CENTENE CLAYTON CAMPUS,
Special Development District, SD1 and SD2A
December 5th Planning Commission and ARB Meeting

December 5th Planning Commission and ARB Meeting

SPECIAL DEVELOPMENT DISTRICT
SDD + Site Plan Review + Architectural Review Board ReSubmittal
December 5, 2016

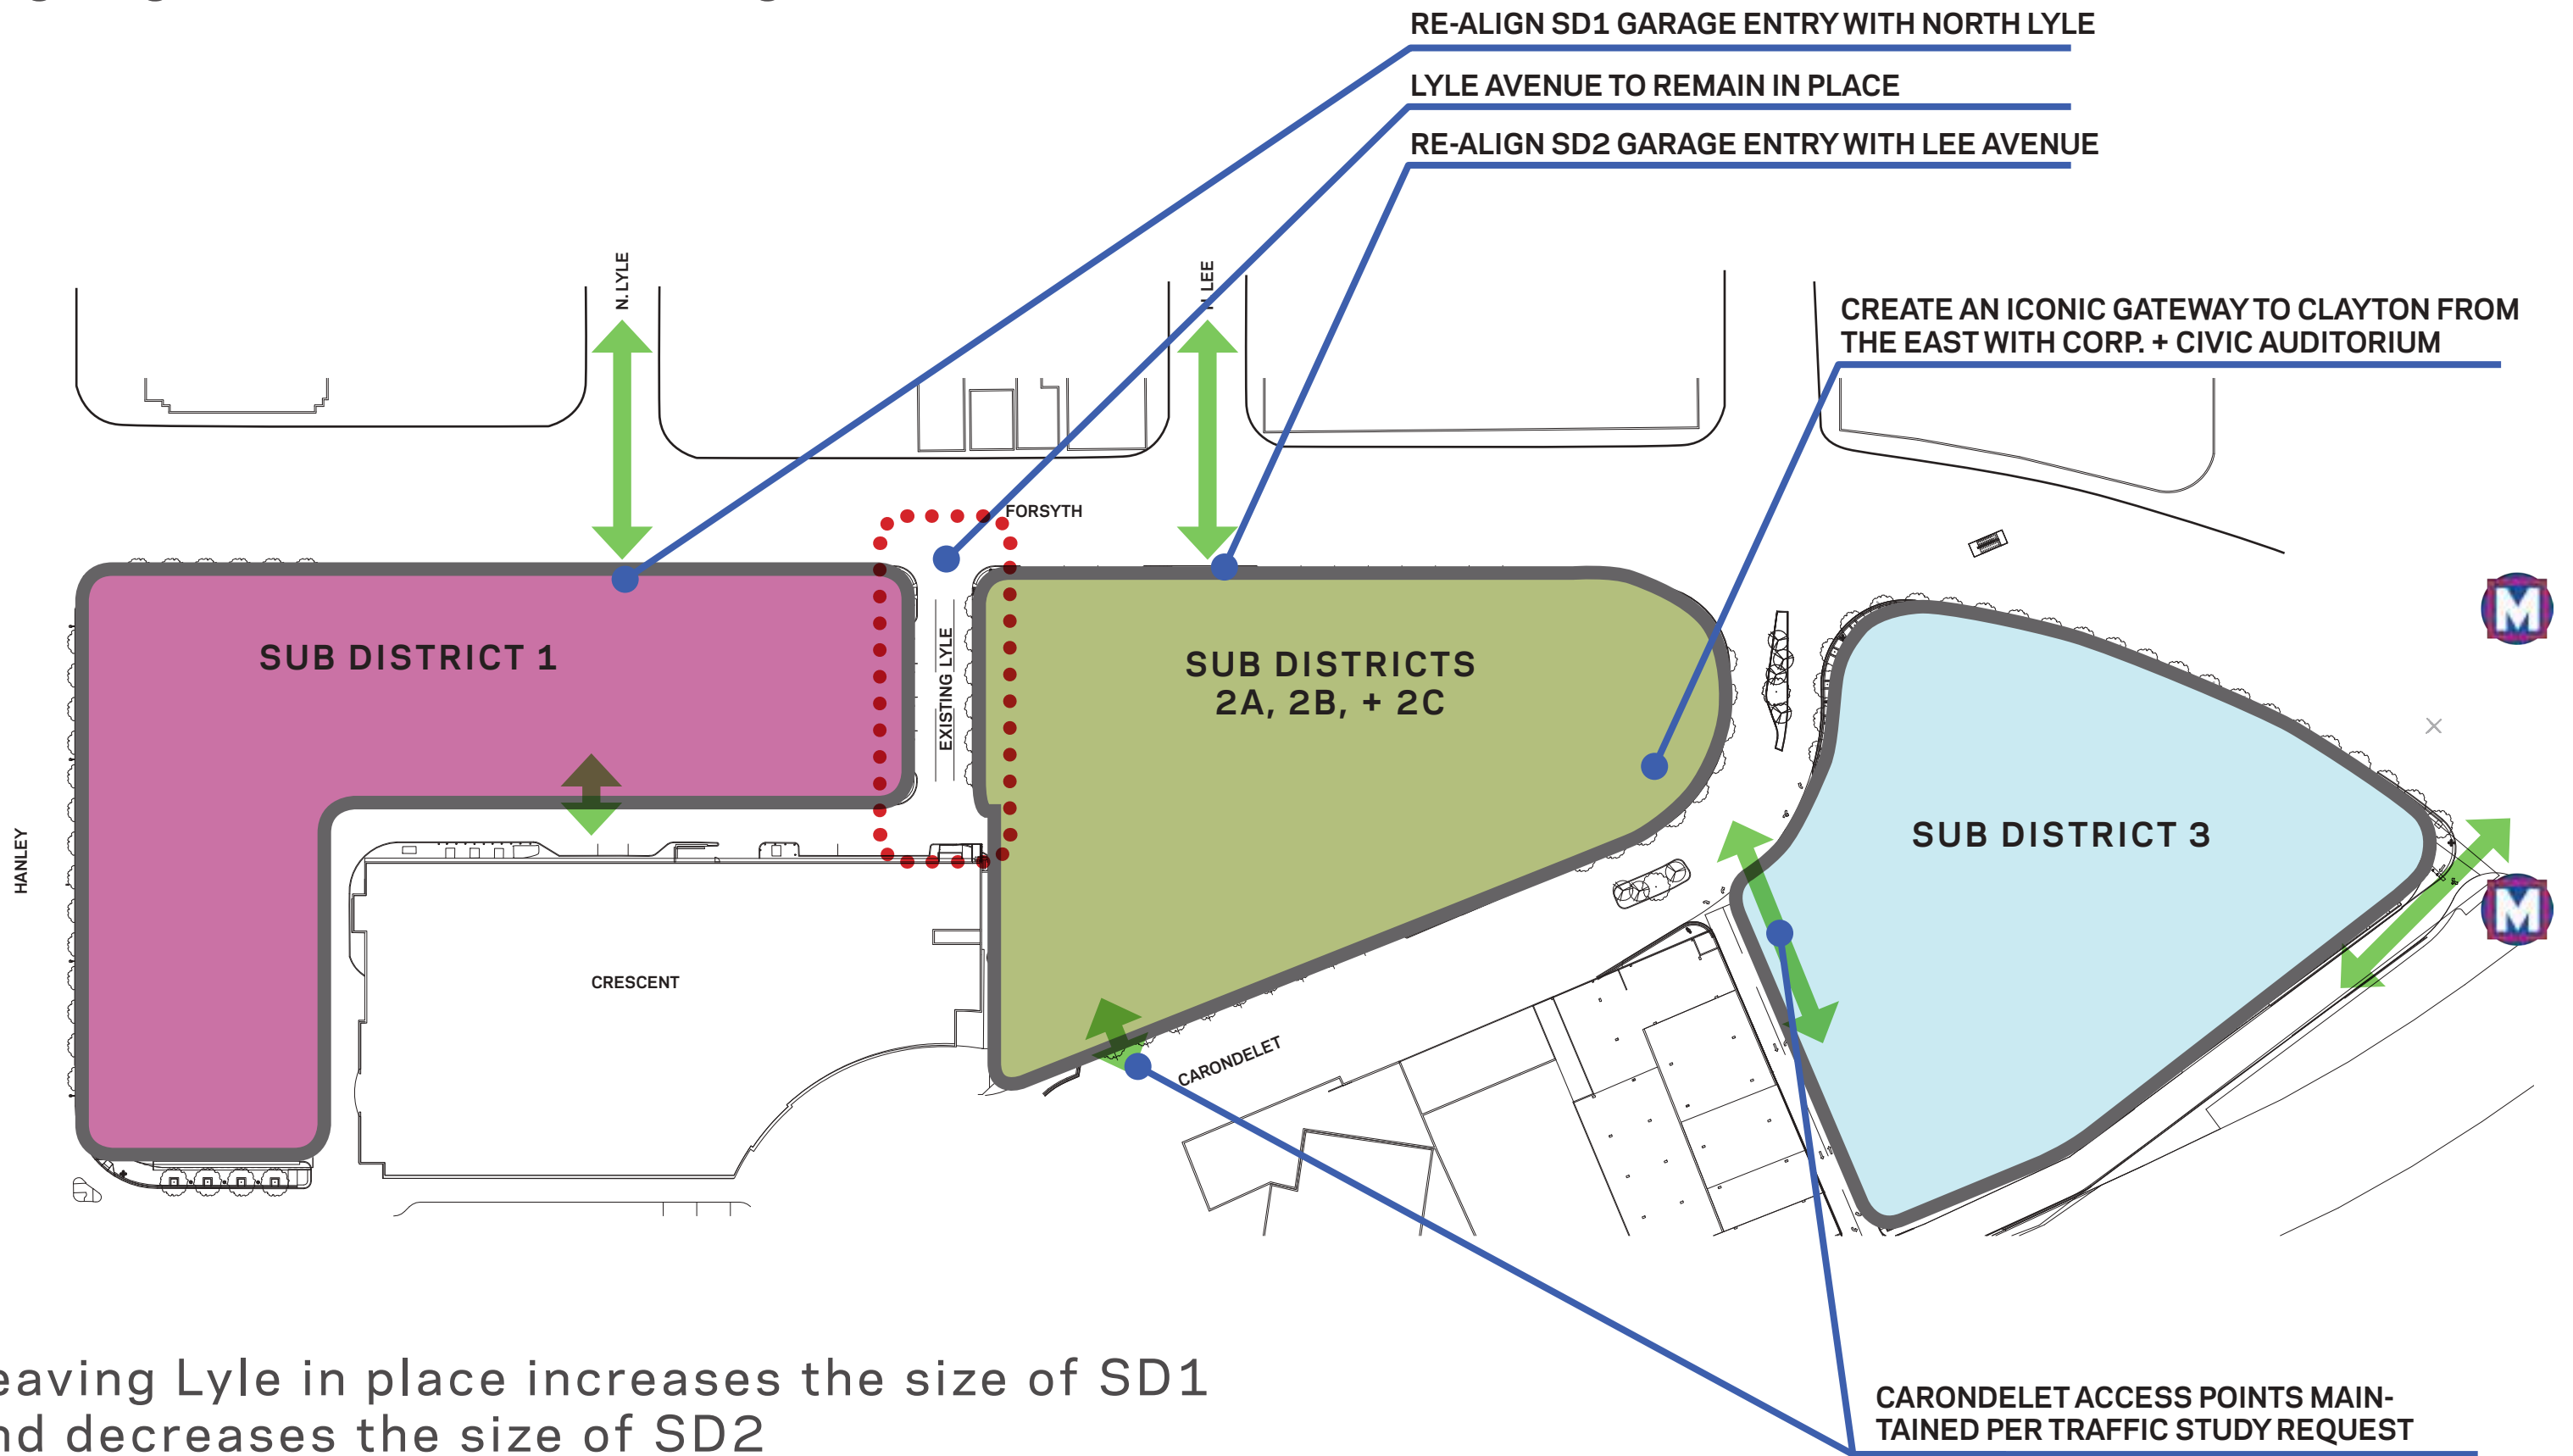
Why is the development team resubmitting the overall SDD?

1. Modify the SD1 and SD2 plan arrangement per comment 8.i.ii, that **leaves South Lyle in place and aligns garage entries at signal locations for existing North Lyle Avenue and Lee.**
2. Per comment 7, modify the SD3 plan to provide a publicly accessible pedestrian connections between the Metrolink station and Subdistrict 3, **[and modify the SD2 plan for a] mid-block between Forsyth Boulevard and Carondelet Plaza in Subdistrict 2.**
3. Per comment 1, **provide active retail, commercial, or residential uses along street frontages.**
4. To provide a **true gateway into Clayton from the east by creating an iconic piece of architecture in the new Corporate+Civic Auditorium.**

Response: The development team has updated the overall SDD to reflect the September 2nd City staff and ARB's items for conditional approval that asked the development team to address: traffic, pedestrian connections, and active street frontages.

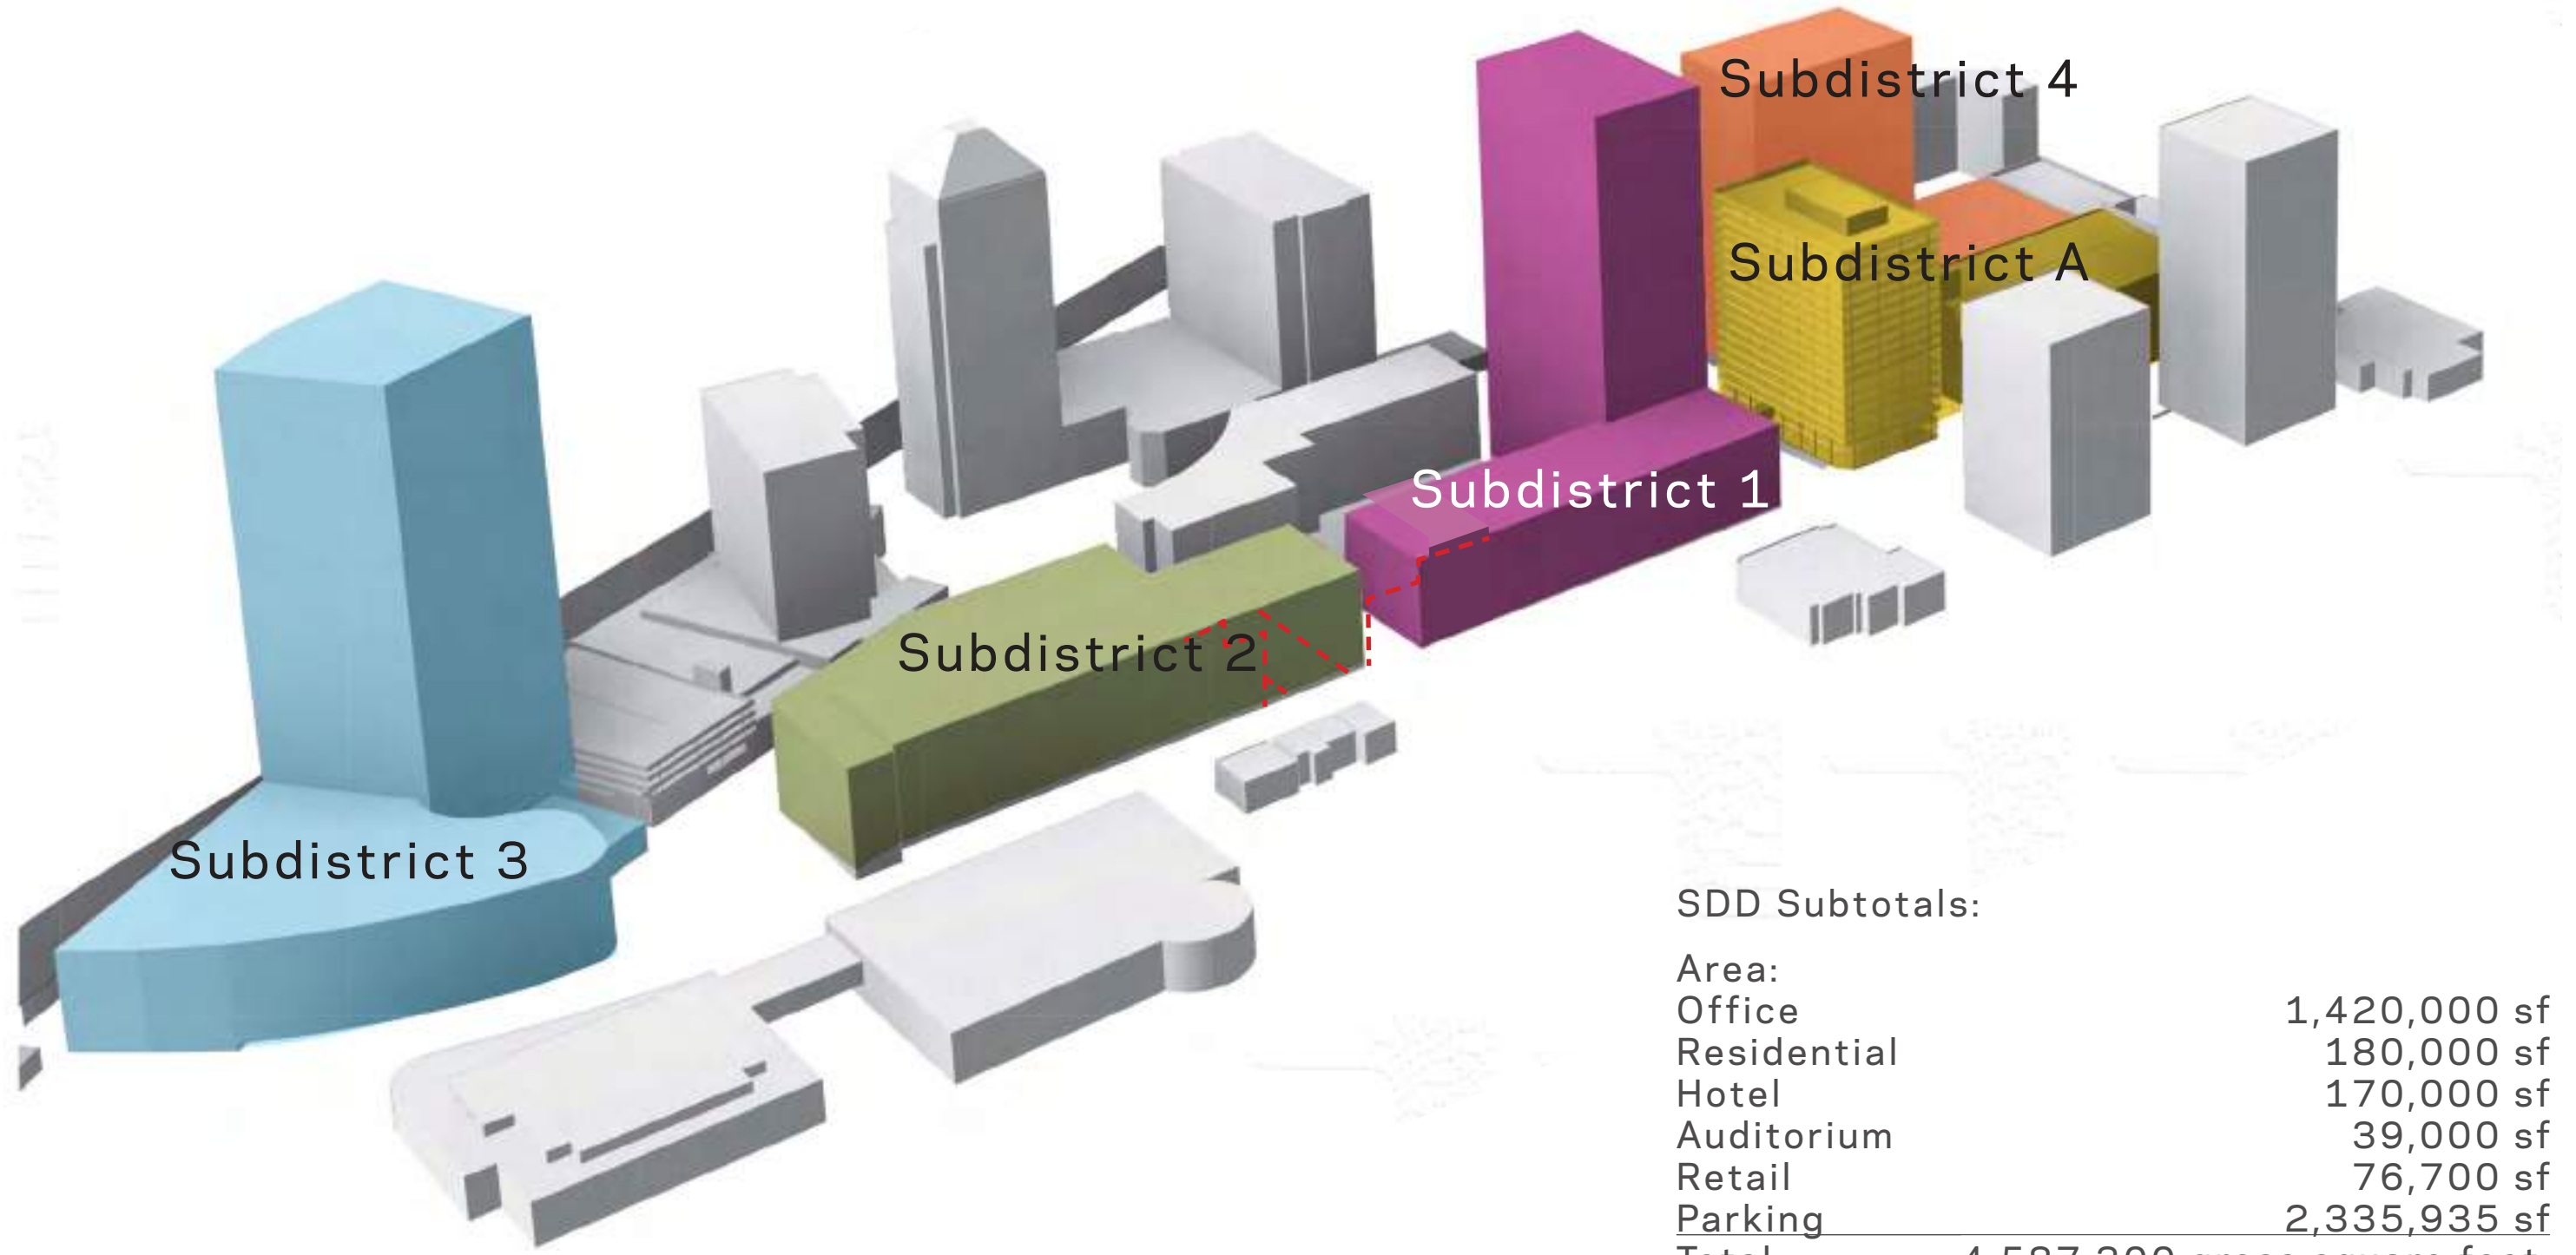
Why is SD2 being broken into three different parcels, and only the garage being submitted today?

Response: In order to facilitate the construction of a new, three-story facility for Wellbridge and street-facing retail at the corner of Forsyth and Hanley, new parking must be accommodated quickly on SD2. This will allow for concurrent construction of the SD1 tower and parking on 2A, with the SD1 garage phased after Wellbridge is relocated to the new facility.

Phase 2B will construct the new Corporate+Civic Auditorium.

Phase 2C will construct a new residential development.

Given their complexity of design, 2B and 2C will have longer timeframes to develop and seek approvals than the planning of the 2A garage.

Planning + design stipulations from ARB+BoA in September

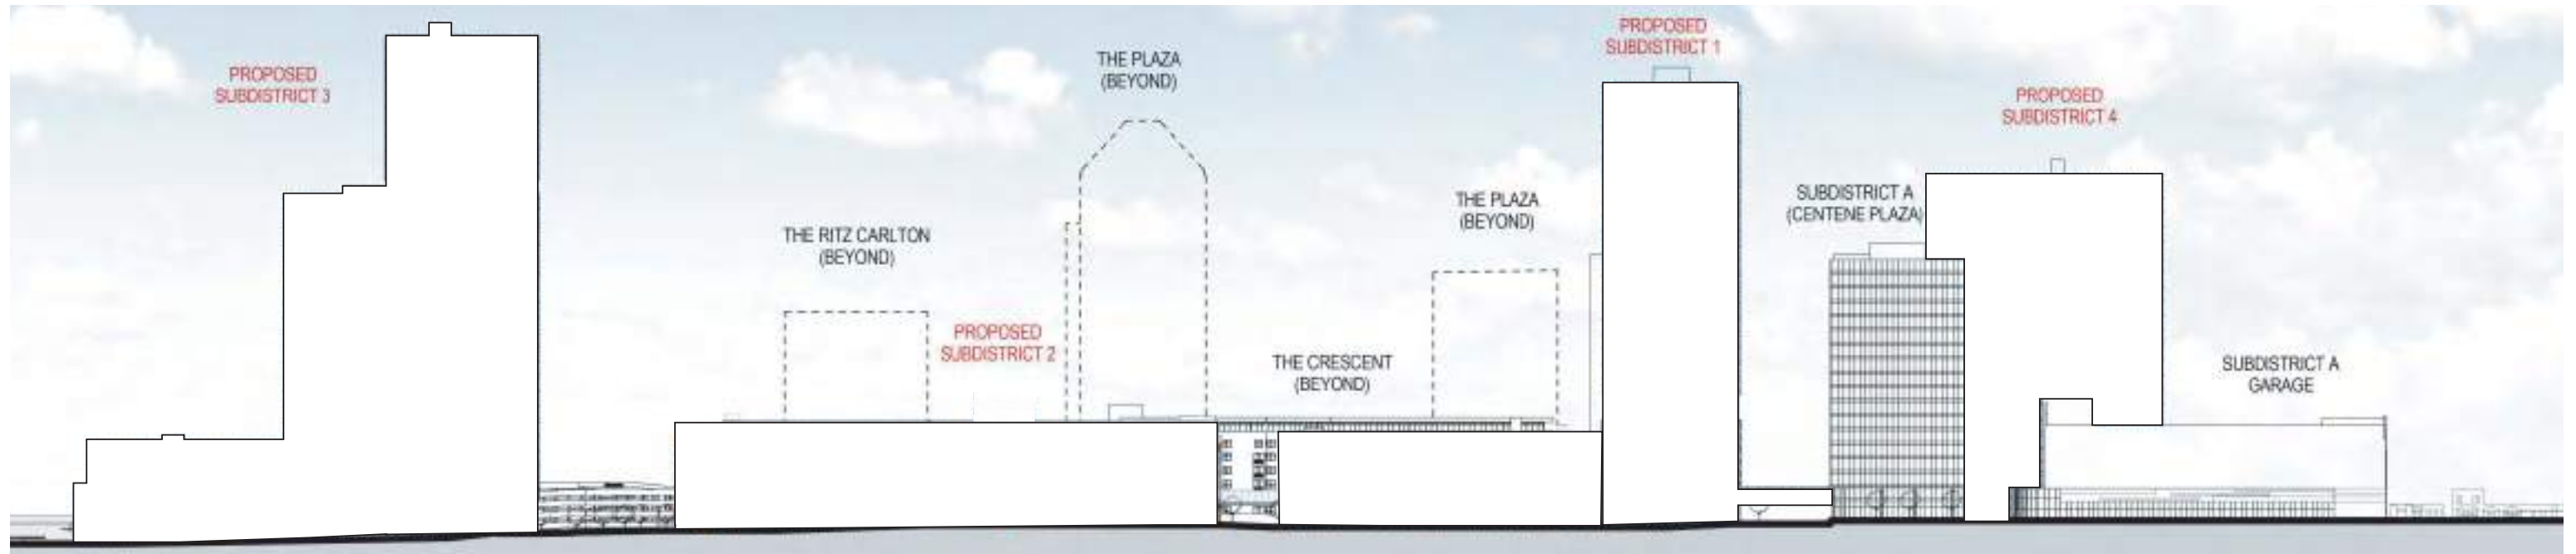
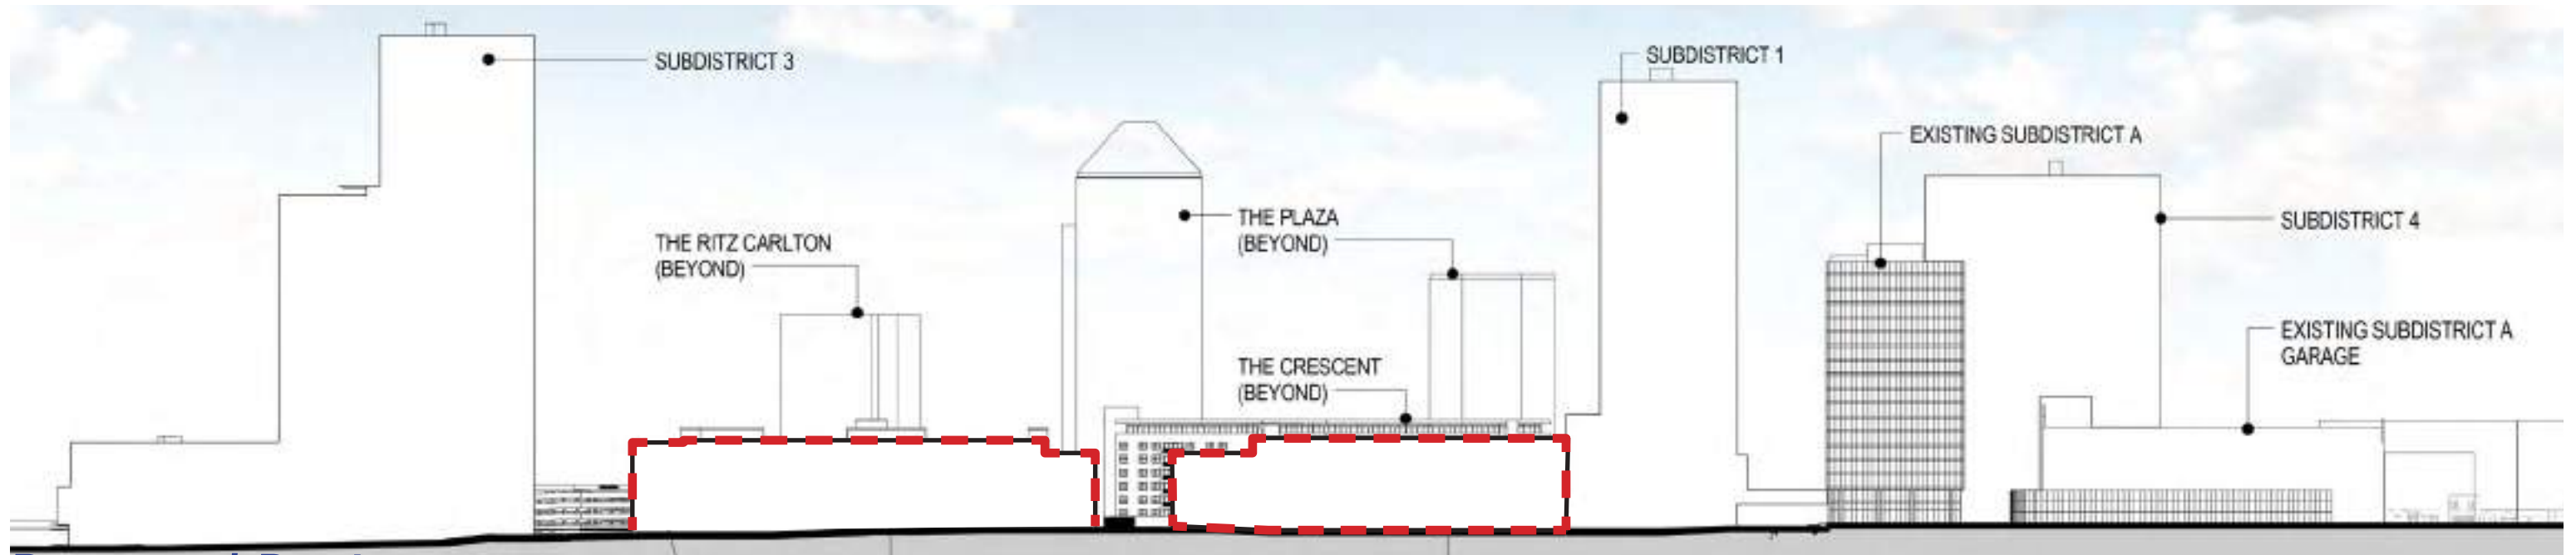
2: Garage / retail buildings along Forsyth will have height not to exceed 89'-6" from mean grade along Forsyth, with two additional step-downs in height. Step-downs will be a 20' reduction in height for 30' east of Lyle Avenue and 60' west of Lyle Avenue.
